E. NEW BUSINESS

- 4. Kenai Horse Trails Subdivision; KPB File 2025-012
Edge Survey & Design / Udelhoven Rentals, LLC
Location: Yukon Road & Scaup Street
Kasilof Area**

**ITEM #4 - PRELIMINARY PLAT
Kenai Horse Trails Subdivision**

KPB File No.	2025-010
Plat Committee Meeting:	February 24, 2025
Applicant / Owner:	Udelhoven Rentals, LLC
Surveyor:	Veronica Bojko / Edge Survey and Design
General Location:	Yukon Road, Kasilof area

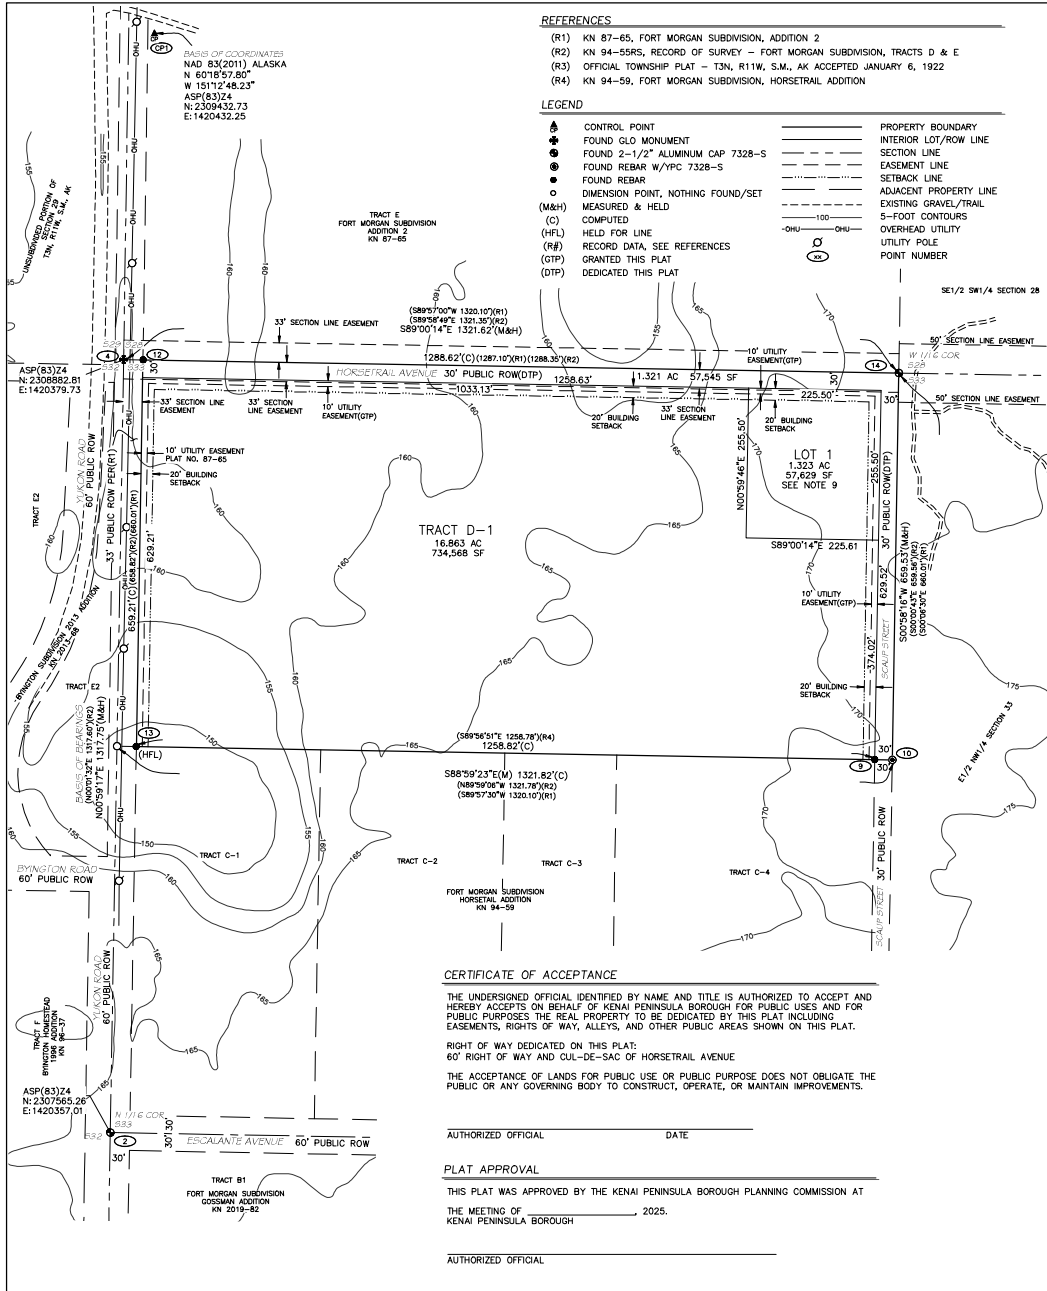
The proposed plat dedicates two roads: Horsetrail Avenue to the north and Scaup Street to the east. Horsetrail Avenue is a 30-foot dedication that will begin from the intersection of Yukon Road, extending east. Scaup Street is a 30-foot dedication extending the Scaup Street dedication from the south. Potential future subdividing of the adjacent parcels abutting the subdivision will be able to provide additional right-of-way for the proposed dedications. Horsetrail Avenue will provide access to both proposed tracts and the unsubdivided parcel to the east. **Staff Recommends** the surveyor modify “Horsetrail Avenue” to “Horse Trail Avenue” per the KPB Addressing Officers review.

Contours have been provided on the plat and confirming with the KPB GIS contours layer. There are no steep slopes with slopes not exceeding 10% across the plat. No wetlands affect this property according to KWF Wetlands Assessment. **Staff Recommends** the contours to be removed on the final plat.

A blanket easement was granted to Glacier State Telephone Co. on March 5, 1981, as recorded by Book 168, Page 16. **Staff recommends** the surveyor determine the location of the easement and depict and note it on the plat.

- Staff recommendation:**
- *Modify the KPB File No to 2025-012*
 - *The name of the subdivision should include the parent plat's name, please modify to include. Please note Fort Morgan Subdivision, Horse Trail Addition has been used previously.*

- *Please modify the owner's name to "Udelhoven Rentals, LLC"*
 - *Correct the spelling of sheet*
- C. The location, width, and name of existing or platted streets and public ways, railroad rights-of-way, and other important features such as section lines or political subdivisions or municipal corporation boundaries abutting the subdivision;

- Staff recommendation:**
- *Please depict the roads more prominently abutting the subdivision and provide a label for Yukon Road directly to the east traveling north and south. Change the weight of the contours and road ROW lines as the contours show more prominent than the ROWs.*

- *Show location, width, and name of Lucina Avenue*
- D. A vicinity map, drawn to scale showing location of proposed subdivision, north arrow if different from plat orientation, township and range, section lines, roads, political boundaries, and prominent natural and manmade features, such as shorelines or streams;

- Staff recommendation:**
- *Either reduce how many sections are shown or label all sections and lakes with names if available.*
 - *Make roads more prominent*

- Staff recommendation:**
- *Add CTP # 4*
 - *Add CTP #15*

- o Correct Tract E2, KN 2013-68, to the west to “Tract E3” and name of subdivision to the south to “Horstrail Addition”
